Addendum No. 2

BND SOUTH PORT CONNECTOR ROAD

October 17, 2019

PORT OF BROWNSVILLE the port that works	
FUTURE SOUTH PORT CONNECTOR PROPOSED FENCE	
DRAWN BY : PE	APPROVED BY :
DATE DRAWN : Oct 2019	REVISION DATE :
CHECKED BY : A. CHAVEZ II	DWG. NO. :
SCALE : AS SHOWN	FILE NAME : C:\MY DRAWINGS\517Security\SouthPortConnectorFence.dwg

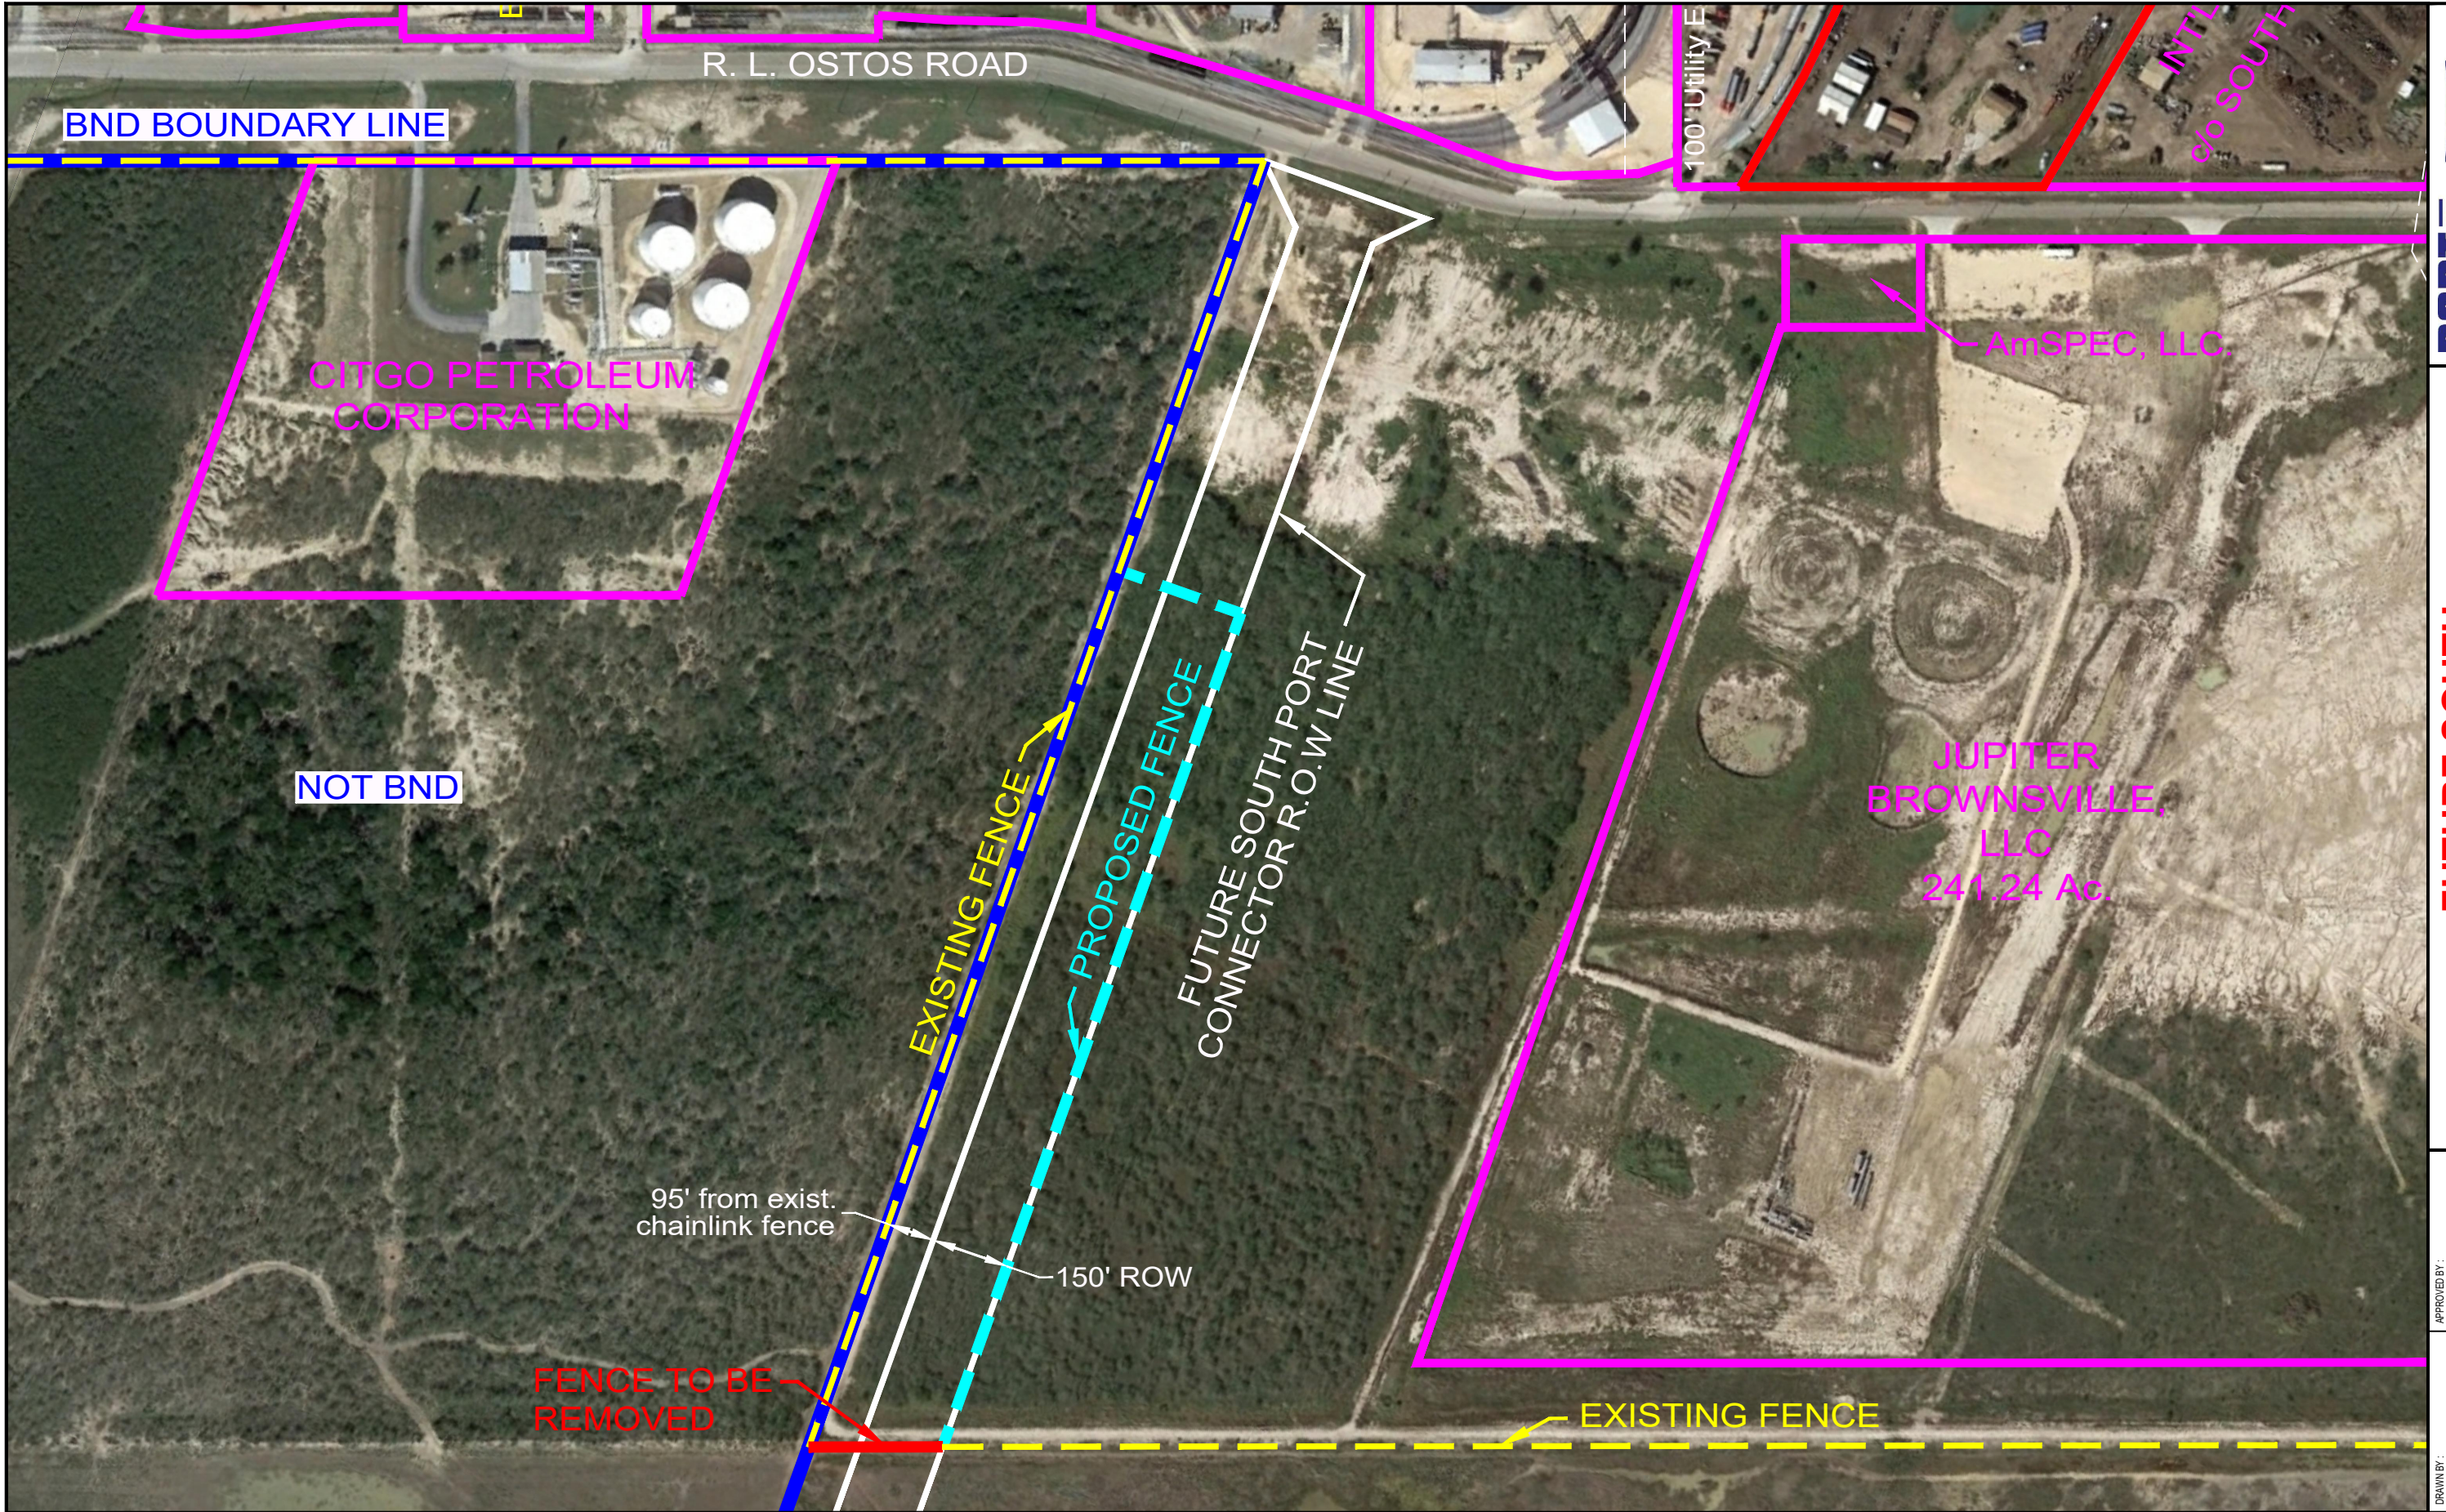
- a. The Port of Brownsville is a secured Port facility and must maintain that status without exception. A portion of the work as a part of the project includes work on both sides of the secured perimeter.
- b. The Port expects for the successful bidder to perform the portion of work inside the secured perimeter from the inside, and the work outside the secured perimeter from the outside.
- c. The Port will make every effort to closely coordinate with the successful bidder to facilitate activities immediately at the crossing of the current secured perimeter.
- d. Upon completion of the work inside the Secure perimeter, the Port will relocate the fence as depicted in the attached Fenced Perimeter drawing, in close coordination with the successful bidder.

SOUTH PORT CONNECTOR
BRIDGE SLAB DETAIL
BRIDGE #1

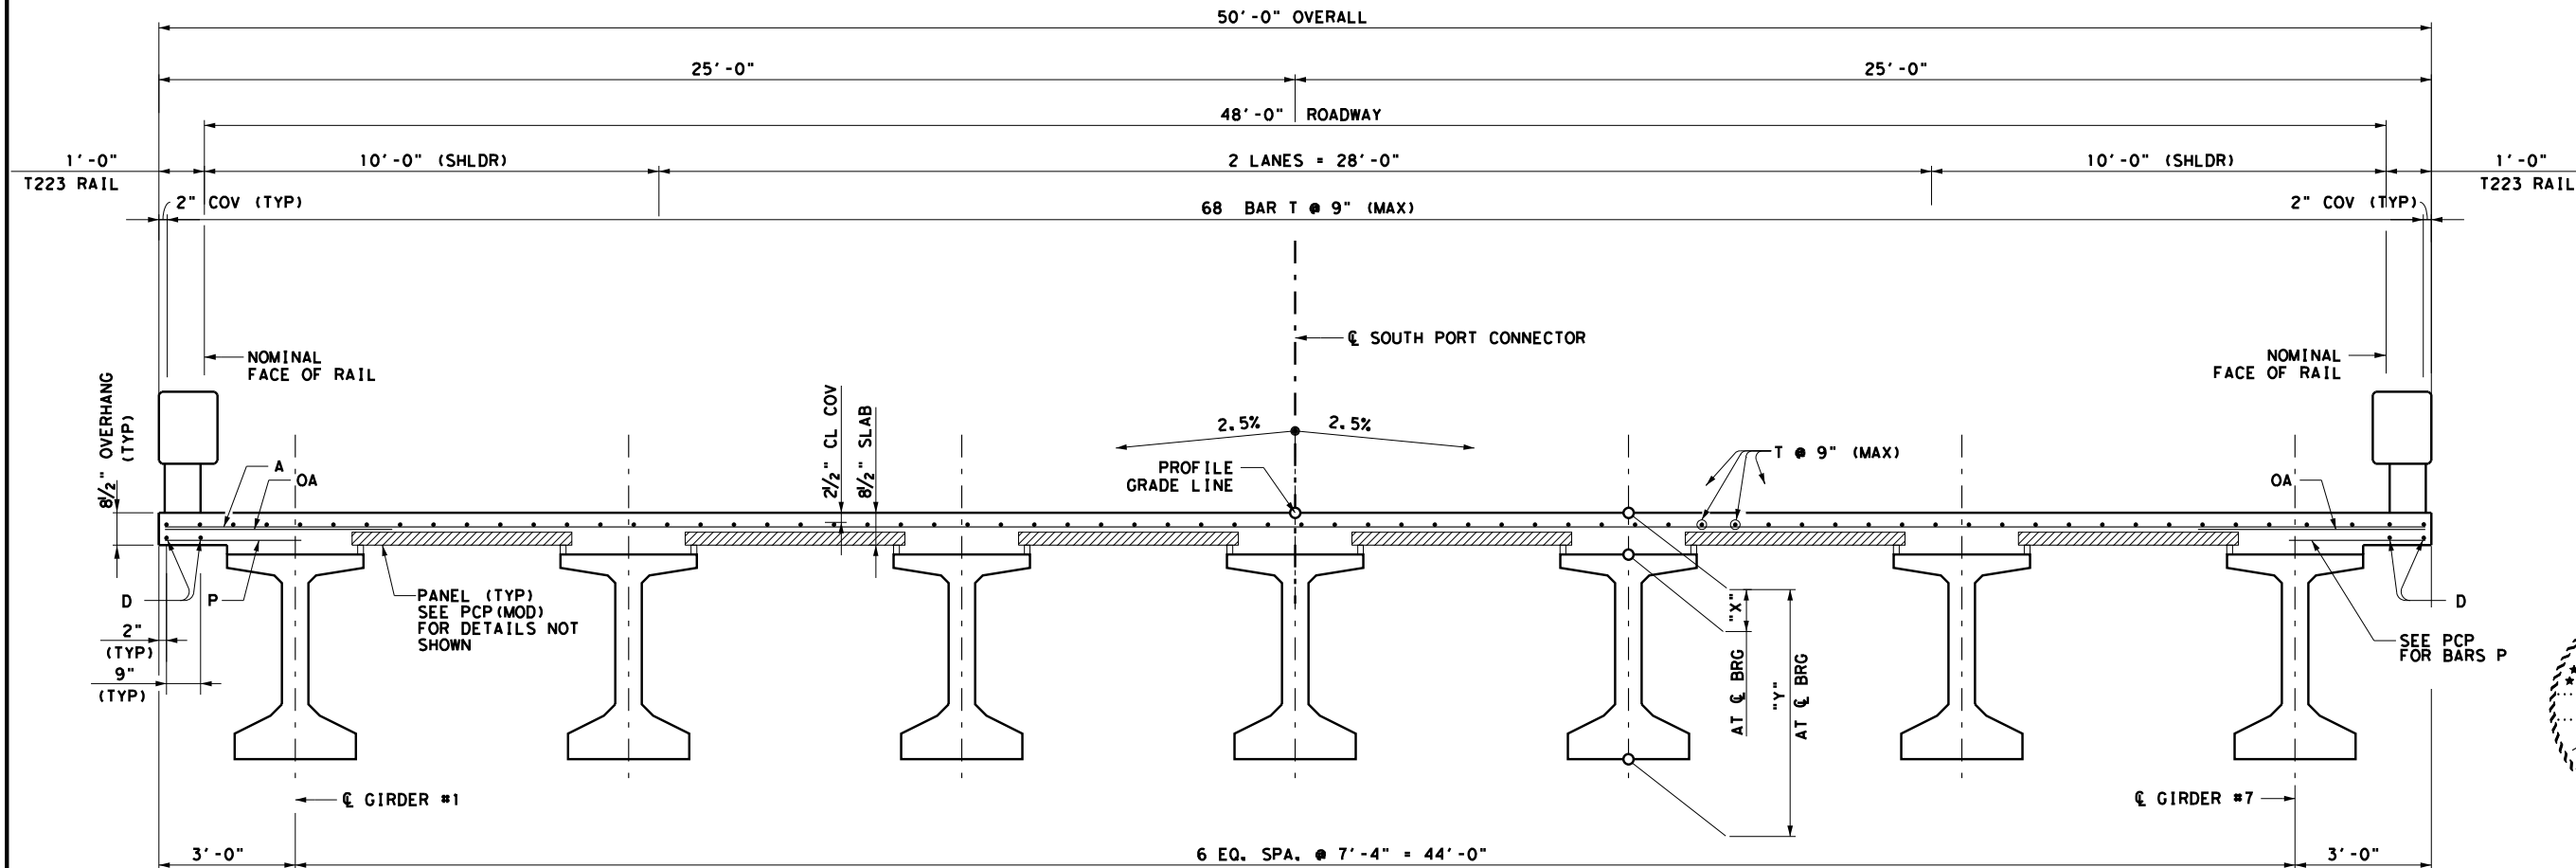
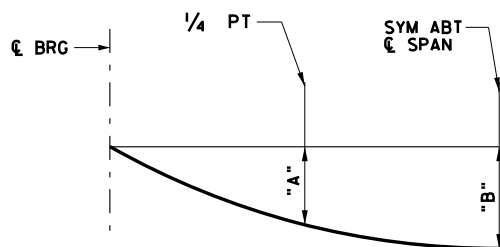
- a. All concrete structures which require steel reinforcement will use epoxy coated rebar. **Sheets 83 and 105** of the construction plans have been updated and attached to this addendum to reflect this.

REV.	DATE	DESCRIPTION	DESIGN	APPRV.
1	10/8/2019	ADDED EPOXY COATING TO REINF. STEEL INCREASED #4 BAR LAP LENGTH	HH	JL
REV.	DATE	DESCRIPTION	DESIGN	APPRV.

① PROVIDE GRADE 60 EPOXY COATED REINFORCING STEEL.

PROVIDE BAR LAPS, WHERE REQUIRED, AS FOLLOWS: EPOXY COATED ~ #4 = 2'-5"

SOUTH PORT CONNECTOR
BRIDGE SLAB DETAIL
BRIDGE #2

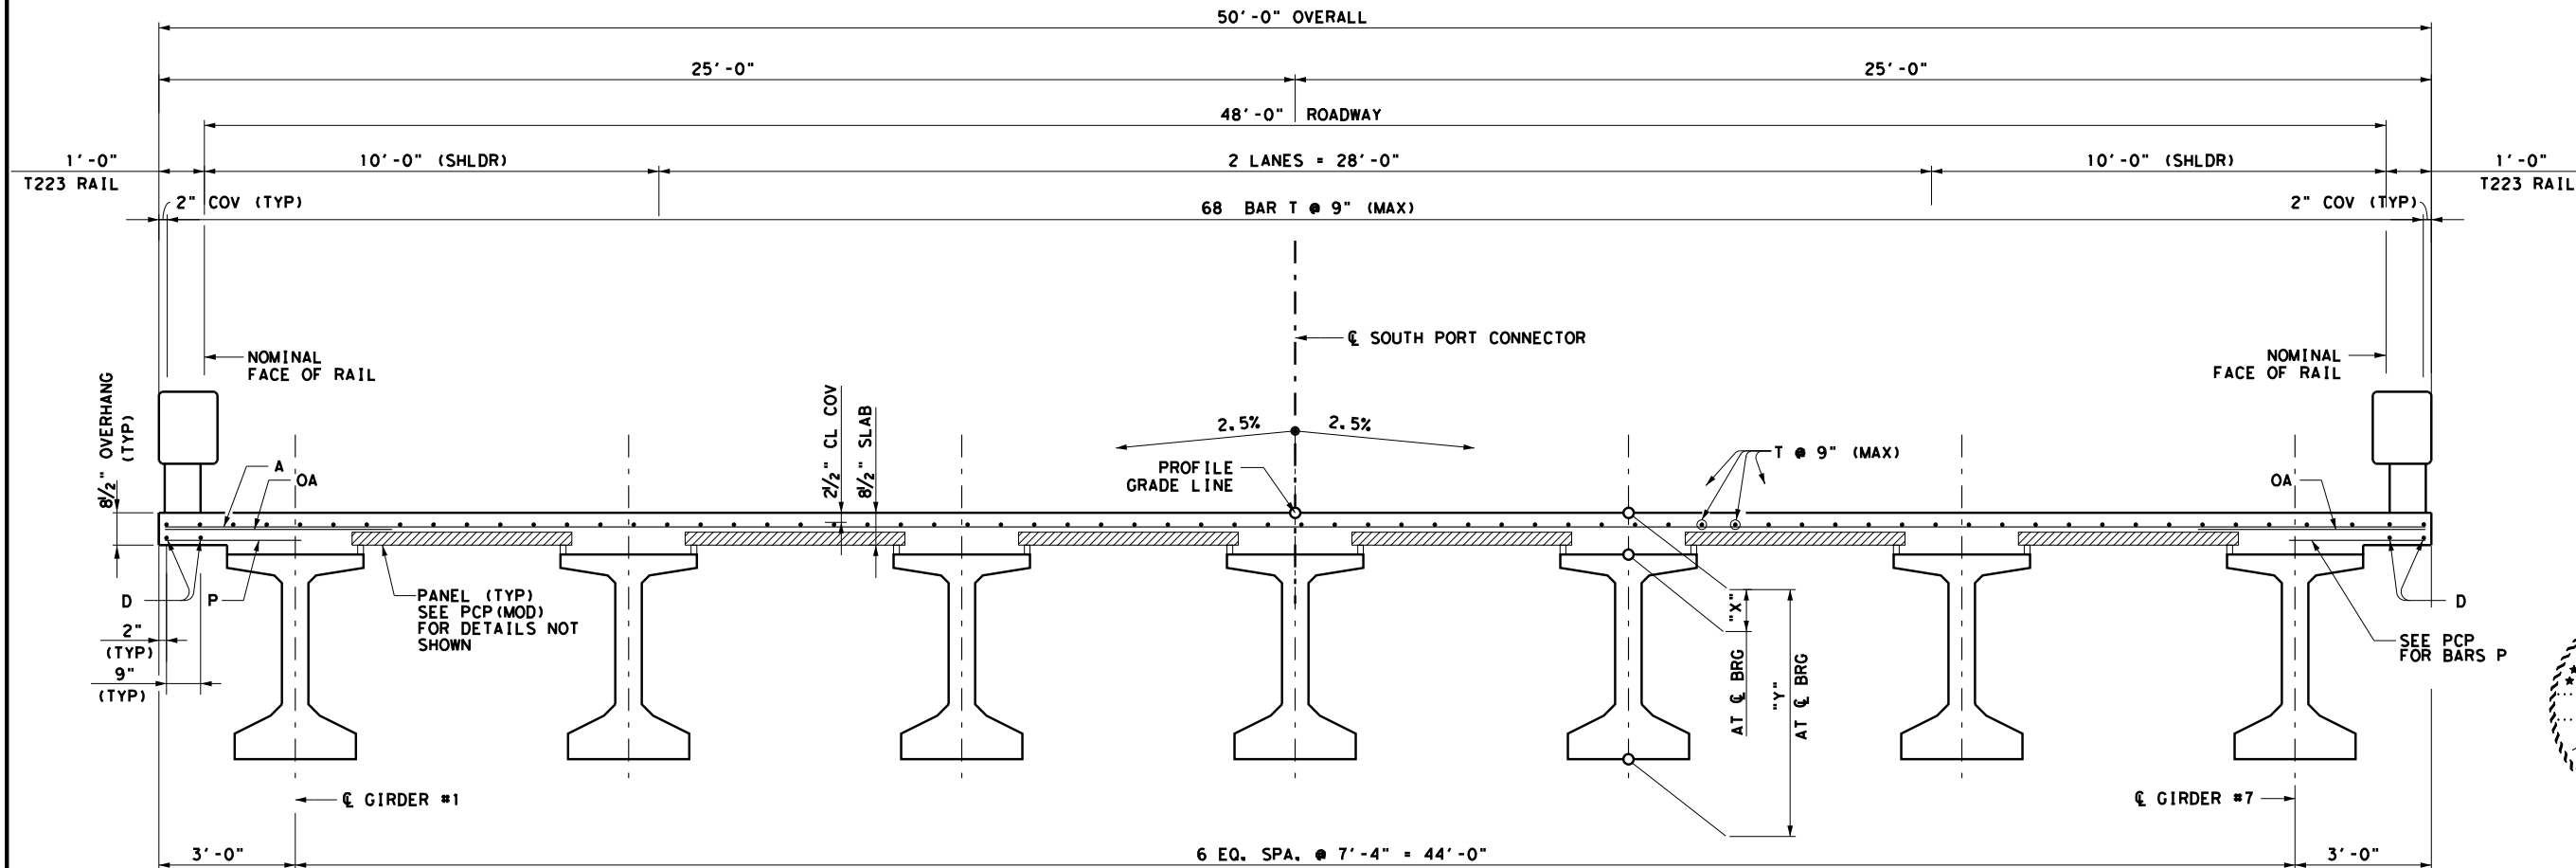
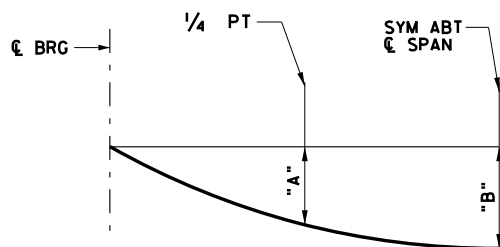
REV.	DATE	DESCRIPTION	DESIGN	APPRV.
1	10/8/2019	ADDED EPOXY COATING TO REINF. STEEL INCREASED #4 BAR LAP LENGTH	HH	JL
REV.	DATE	DESCRIPTION	DESIGN	APPRV.

PROVIDE GRADE 60 EPOXY COATED REINFORCING STEEL.

PROVIDE BAR LAPS, WHERE REQUIRED, AS FOLLOWS: EPOXY COATED ~ #4 = 2'-5"
